S.F. Jeans Ltd.

Karol Shurichala, Sofipur, Mouchak, Kaliakoir, Gazipur

Observations

Roof bracing – no obvious compression struts

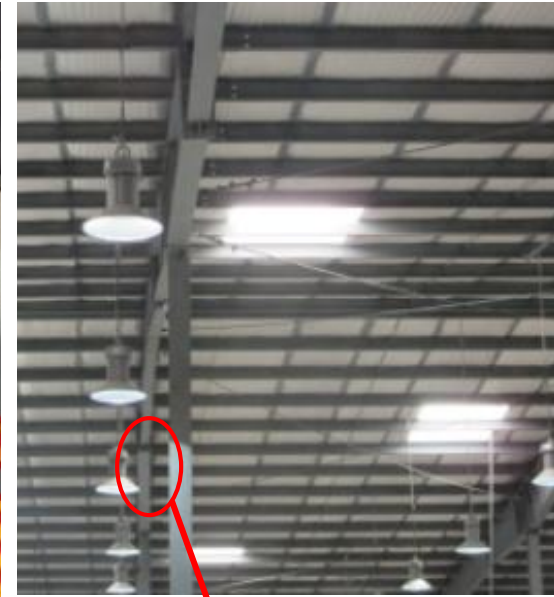
Vertical X-bracing is loose.

The bracing system should be reviewed by the Building Engineer. Some additional works may be required :

1. Tensioning of the bracing tie wires
2. Instalment of the compression struts in roof bracing

Roof girder connection appears to have rotated

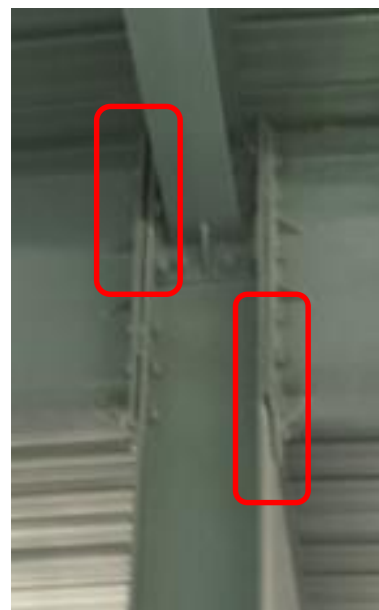
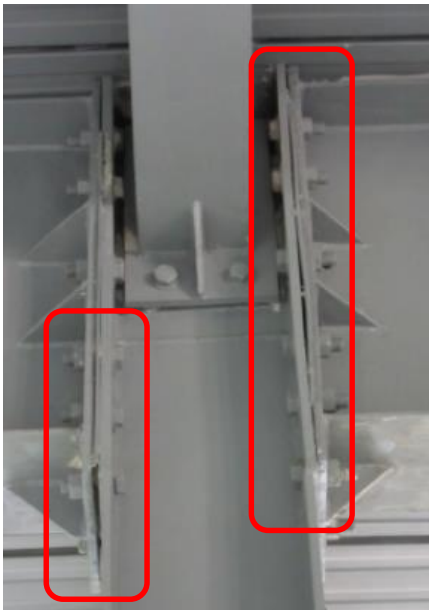
Non-engineered welding of the hanging of the secondary steel work

Defects (gaps and plate deformations) require design check of capacity.

Non-engineered welding of the hangers to steel beams may cause plastic defect in the tension zone of the sections.

Gaps in the bolted connections in many places, require design check

Typical floor plan

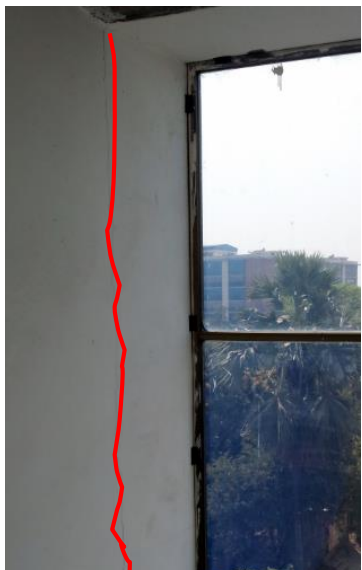
1.2 – 1.4m high stack of rolled Denim
Average load assumed 5 kPa

High toilet build-ups (avg. 100 mm)

9 Observations: Cracking in walls

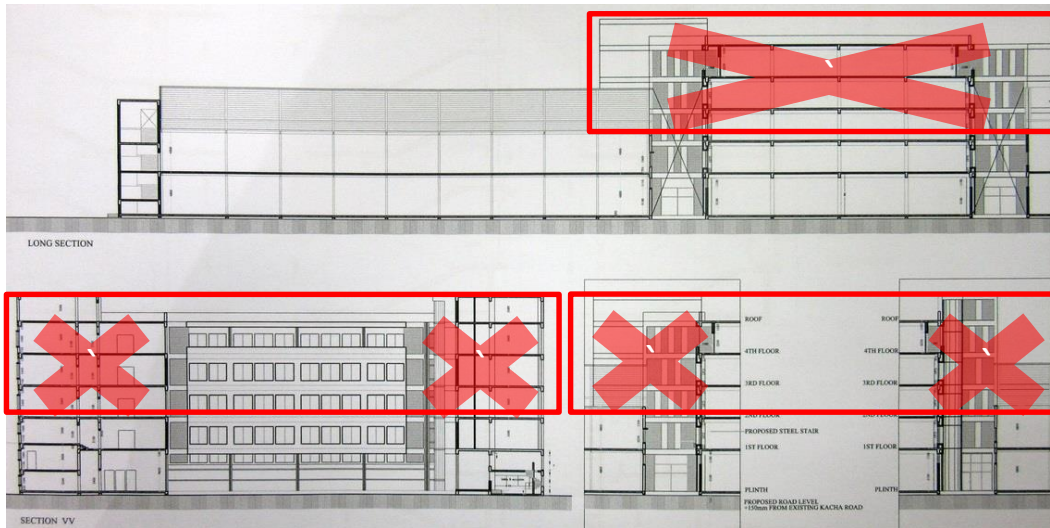
Cracks on the wall in the cantilevers. The cracks width reflects deformations, smaller in bottom , larger at top

Cracks in the staircase

Fully cracked window pillars

The architectural drawings showing completed building

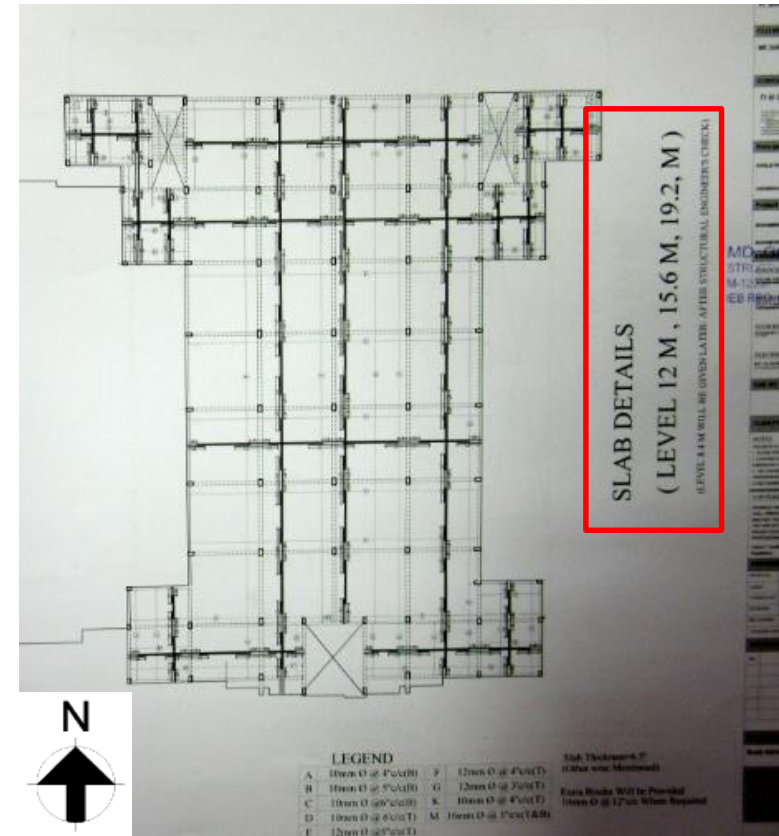
The structural as-built documentation contains details of structural slabs not yet constructed

Currently there are 2 storeys built in the concrete part of the factory
